**PROPOSED MINOR RELAXATION OF BUILDING HEIGHT RESTRICTIONS FOR PUBLIC HOUSING
DEVELOPMENT AT NGAU CHI WAN VILLAGE, KOWLOON (TPB Ref: A/K12/45)**

Attachment 1

Proposed Minor Relaxation of Building Height Restrictions for Public Housing Development at Ngau Chi Wan Village, Kowloon
 (TPB Ref. A/K12/45)
Responses to Comments Table

FIGURE 4.2 PEDESTRIAN CONNECTIVITY

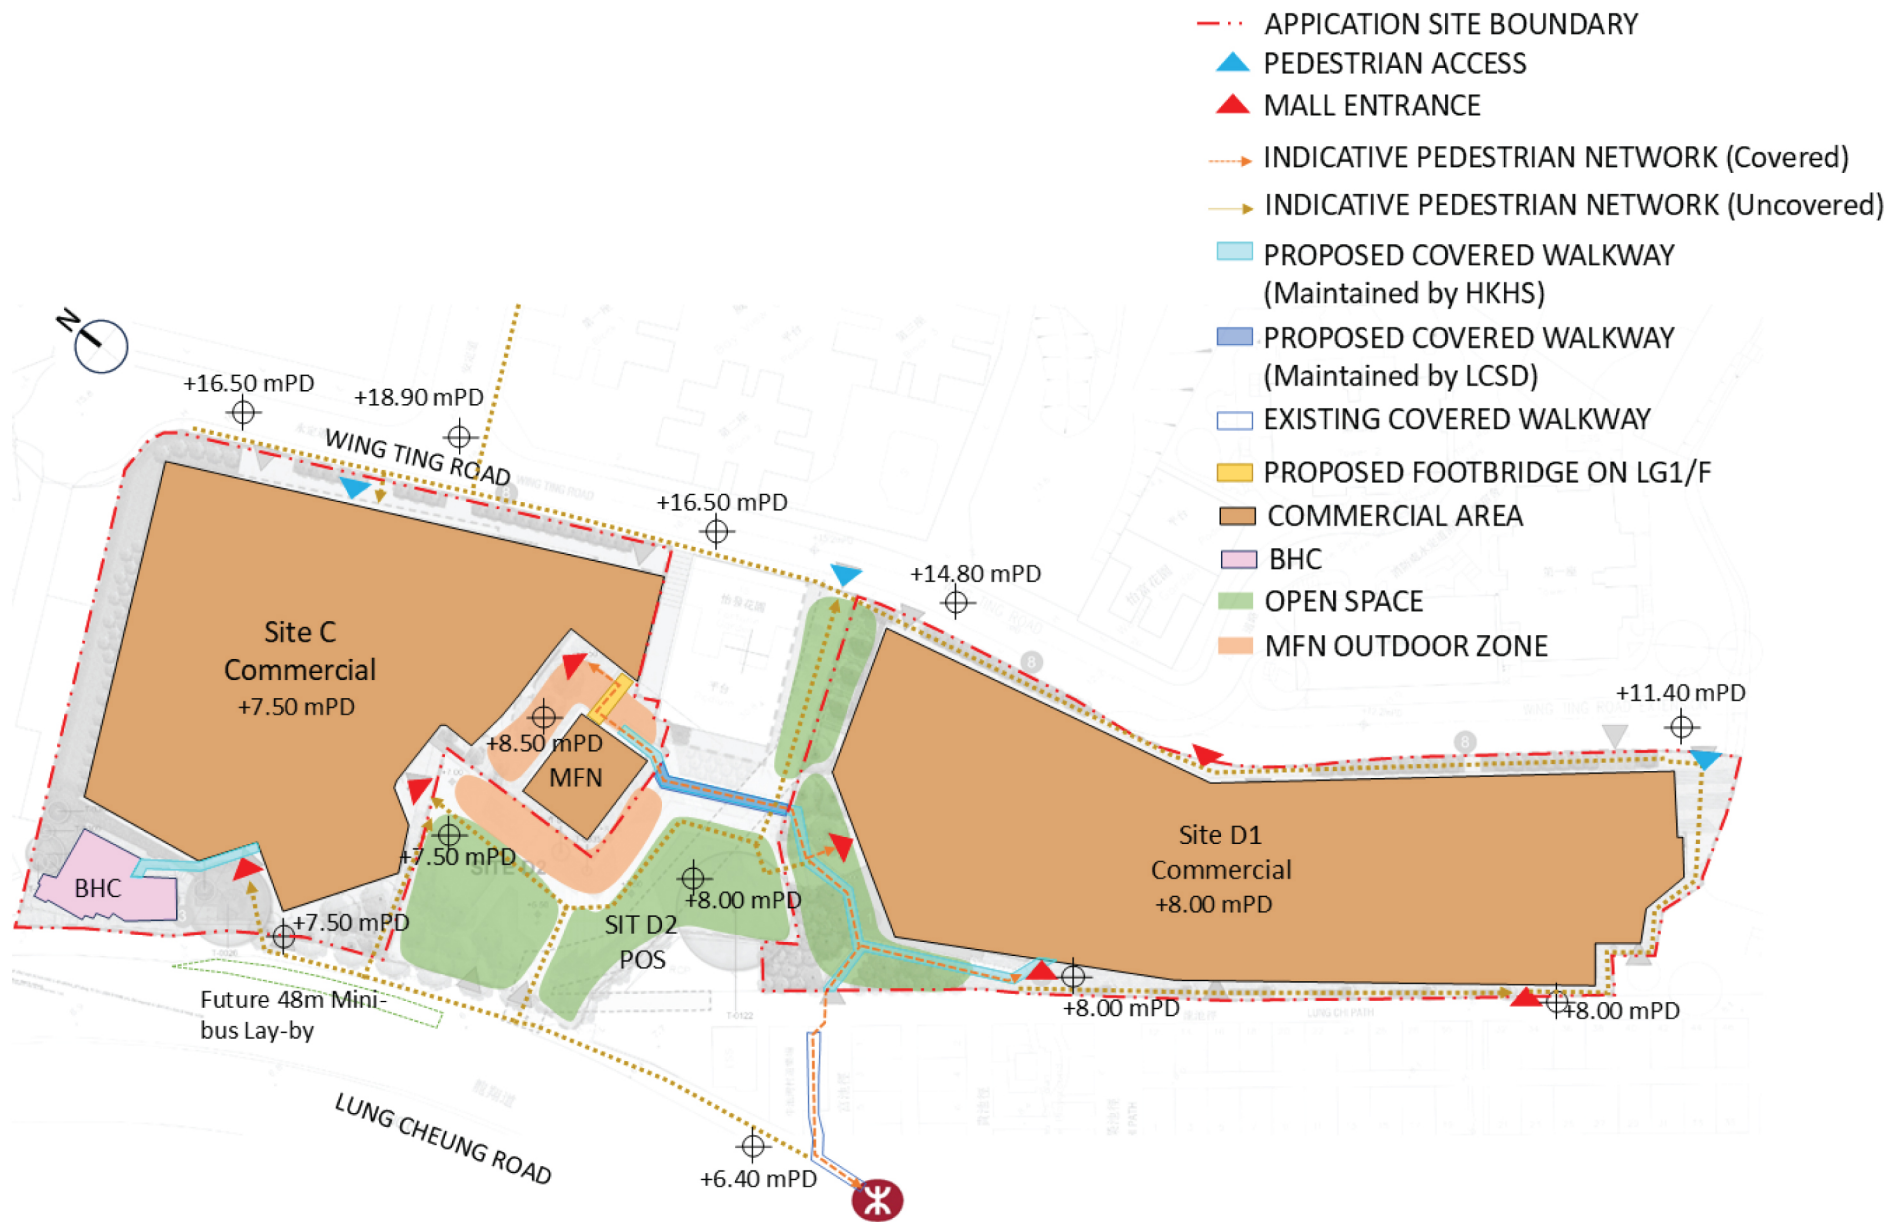
Comments/ Suggestions		Applicant/ Consultant's Responses
8.	<p><u>Planning Statement – Para. 4.3.13</u></p> <p>Please advise if the barrier-free access, lift and route of public passageway from Wing Ting Road to Lung Cheung Road/Lung Chi Path, and further to Choi Hung MTR are 24-hour opening, open-air, with cover/canopy, and the width dimension.</p>	<p>Please note that the barrier free access between Wing Ting Road and Lung Chi Path / Lung Cheung Road provided via shuttle lifts at the retail portion at the podium levels is intended to be opened for public access tentatively from 10am to 10pm, subject to further review at detailed design stage. The covered walkway and canopy (with a width of approx. 2m) will be provided within the site boundary to connect with existing covered walkway (outside of the Application Site) connecting to Choi Hung MTR. The pedestrian connections will be further reviewed and studied at the detailed design stage.</p> <p>Map legends showing the viewing angles of artist's impressions for Site C and Site D1 have been supplemented (Appendix 2 refers).</p> <p>The nos. of TPIs and new trees are indicated on the LMP (Appendix 5 refers).</p>

FIGURE 9 VIEWPOINT 2 : VIEW FROM MTR EXIT NEAR
CHOI HUNG ESTATE

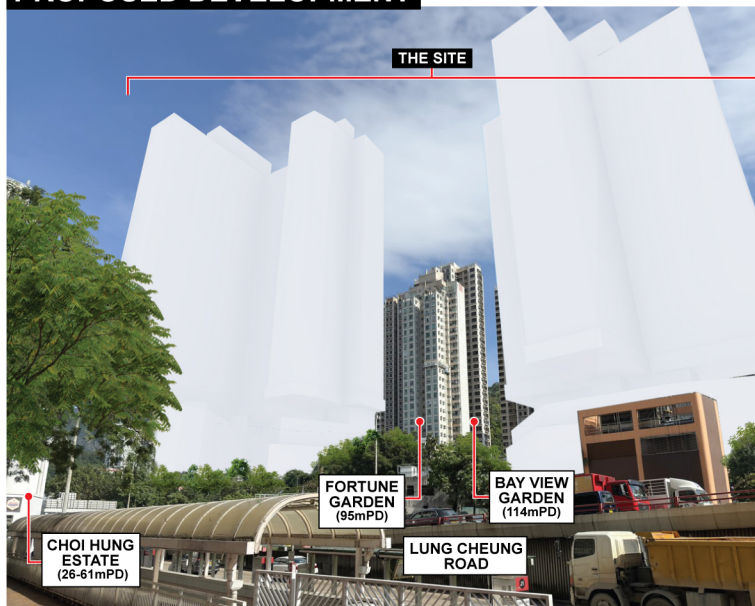
9. VP2, Figure 9, Photomontages - As per our internal checking, it seems that the BHs of both the Baseline Scheme and the Proposed Development are underestimated.	Figure 9 of the VIA has been updated (Appendix 3 refers).
